ISSUE-2

SYMBOL OF QUALITY AN ISO 9001 COMPANY	JINDAL ALUMINIUM LTD. BANGALORE-560073 (INDIA)	DRAWN	NAME	DATE
		CHECKED	J.P.KAUSHIK	14-10-2009
1. ALL DIMENSIONS ARE IN mm. 2. ROUND OFF ALL SHARP CORNERS WITH 0.40 mm. 3. TOLERANCES WILL BE AS PER IS:2673-2002 UNLESS OTHERWISE SPECIFIED		APPROVED		
		SCALE	1:1	
PARTY'S NAME BHARAT ELECTRONICS LTD.,BANGALORE		AREA mm ²	11259.468	
		PERIMETER mm.	848.23	
PARTY'S DRAWING No. AS PER SPECIFICATION		WEIGHT kg/m	30.401	
		DRAWING No.	SECTION No.	
ALLOY & TEMPER 6061 T6		P-9219-2	-	
		S2150	S2150(ISSUE-2)	
DESCRIPTION ROUND TUBE		13514	13514

P-9219-2
S2150
13514

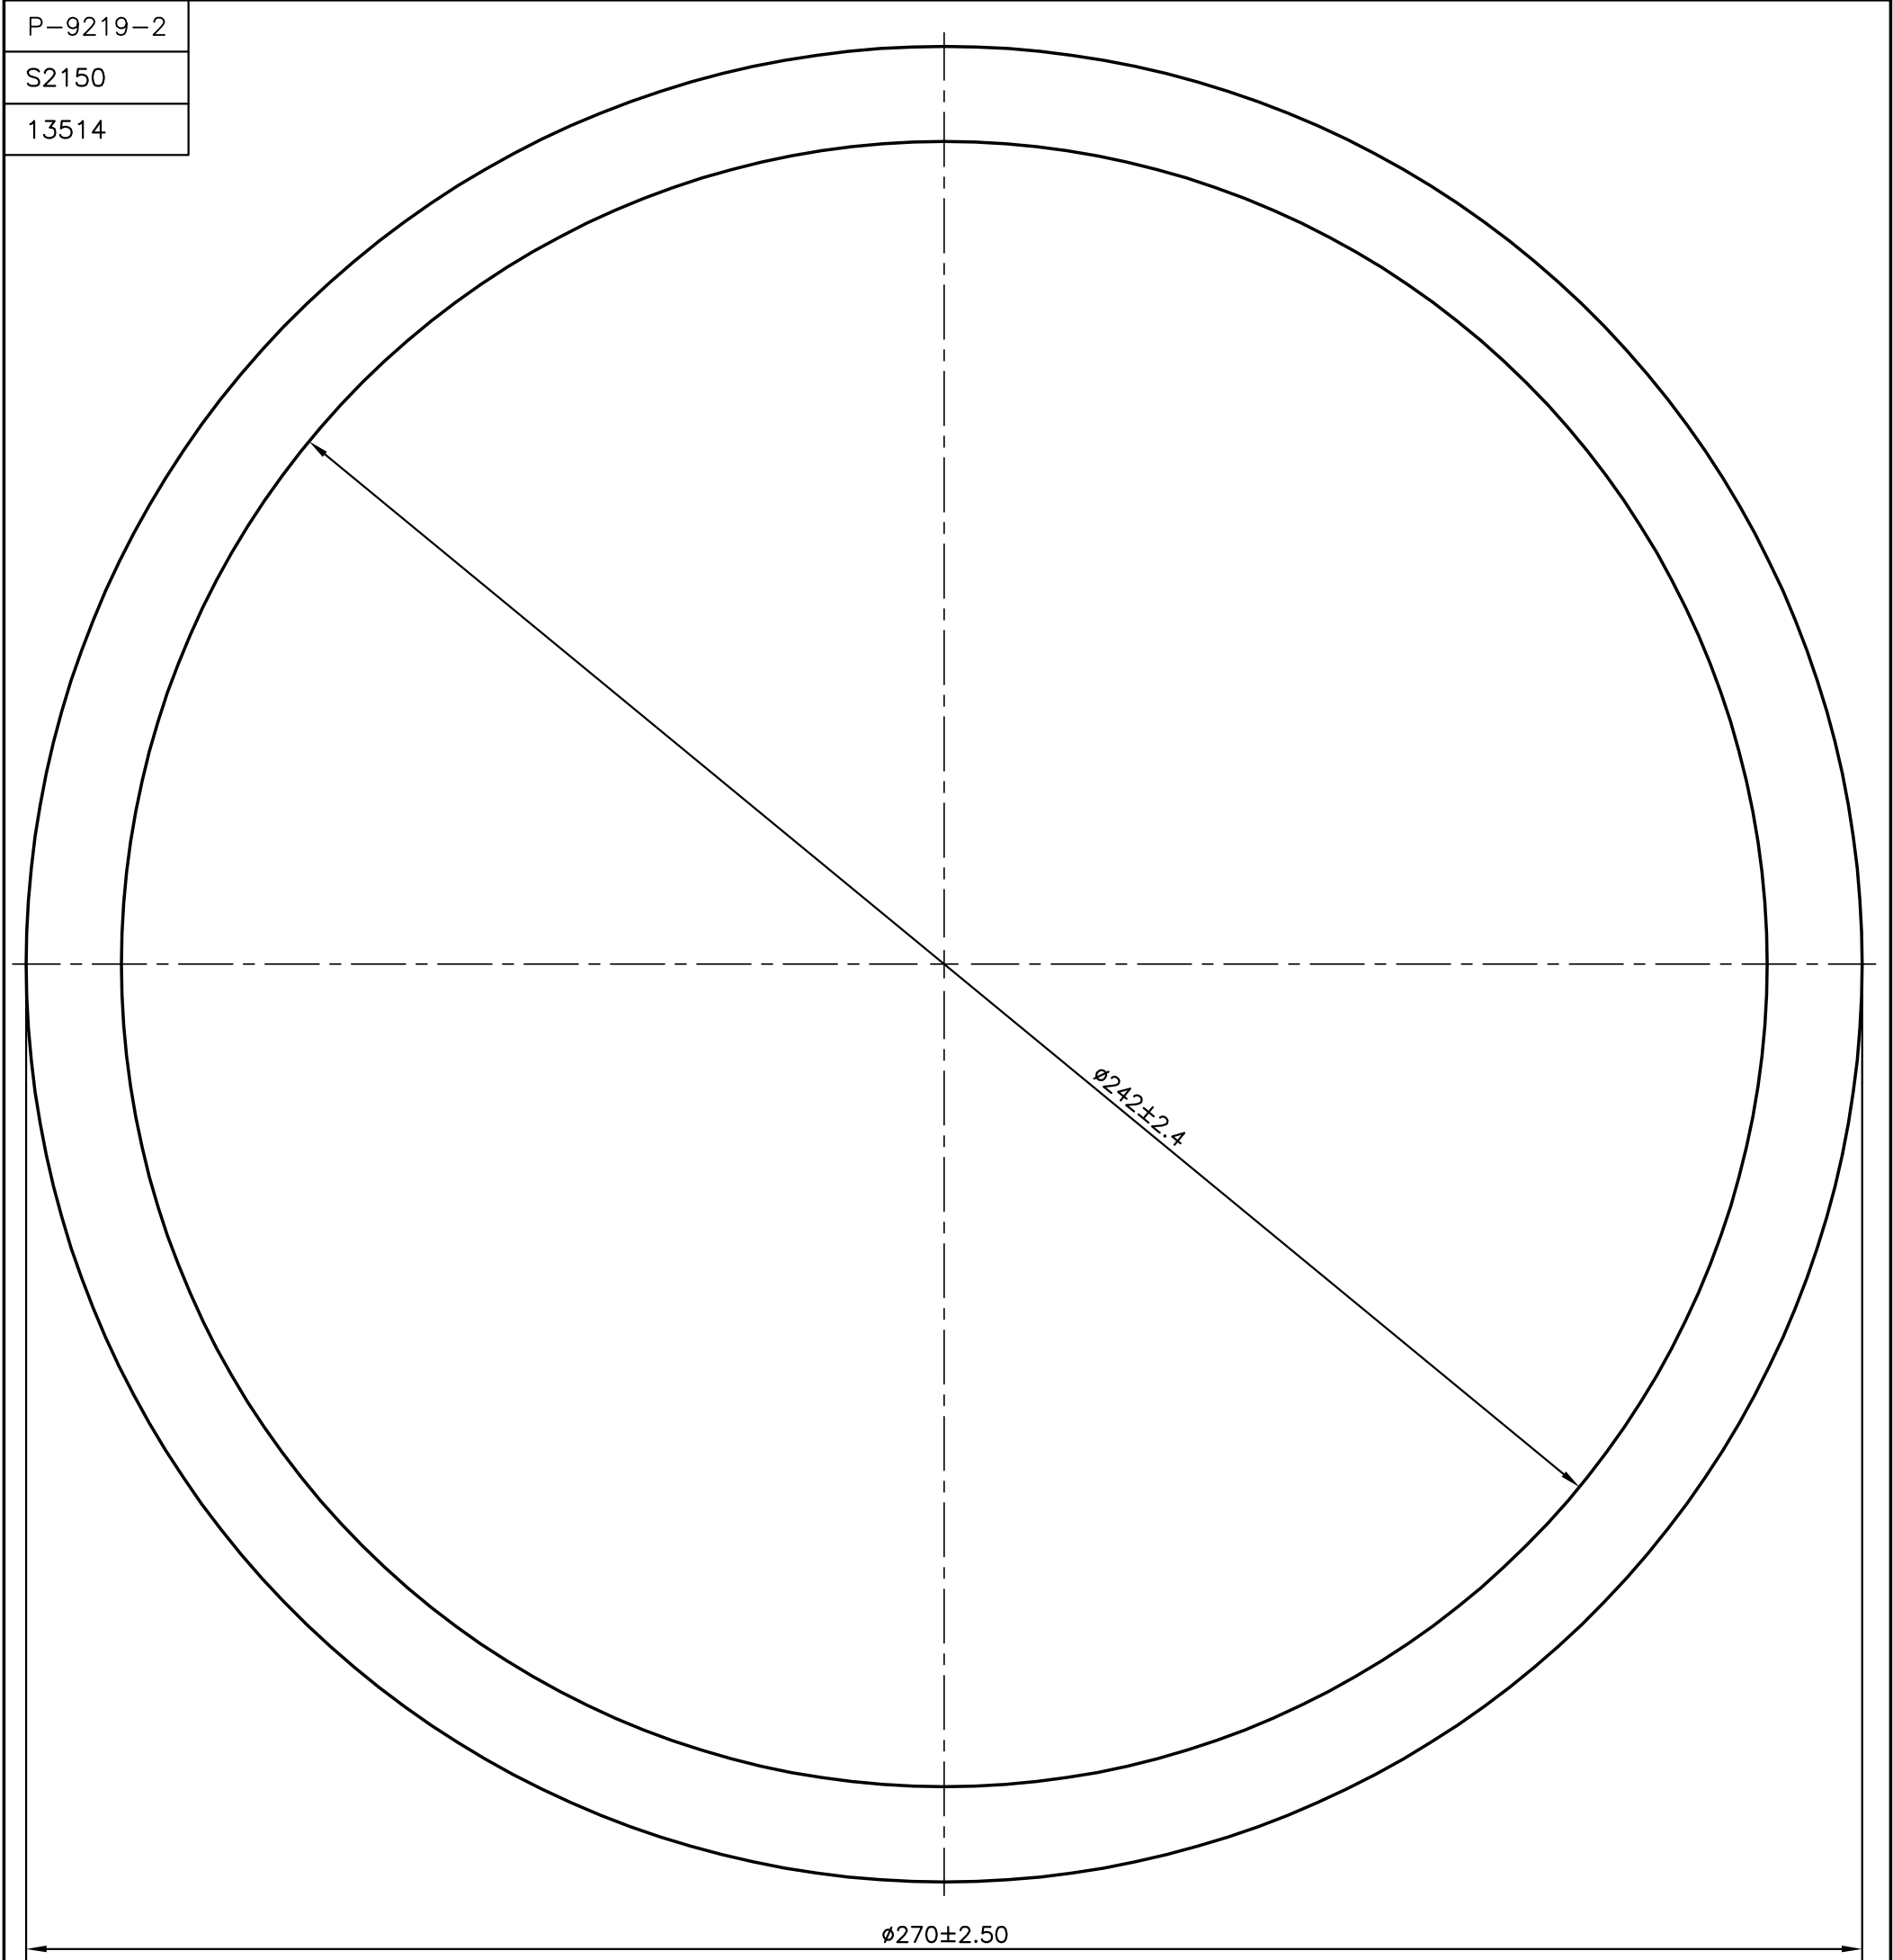
O.D. CHANGED FROM $\phi 265$ TO $\phi 270$, I.D. CHANGED FROM $\phi 246$ TO $\phi 242$
 WEIGHT ALSO CHANGED FROM 20.589 kg/M TO 30.401 kg/M
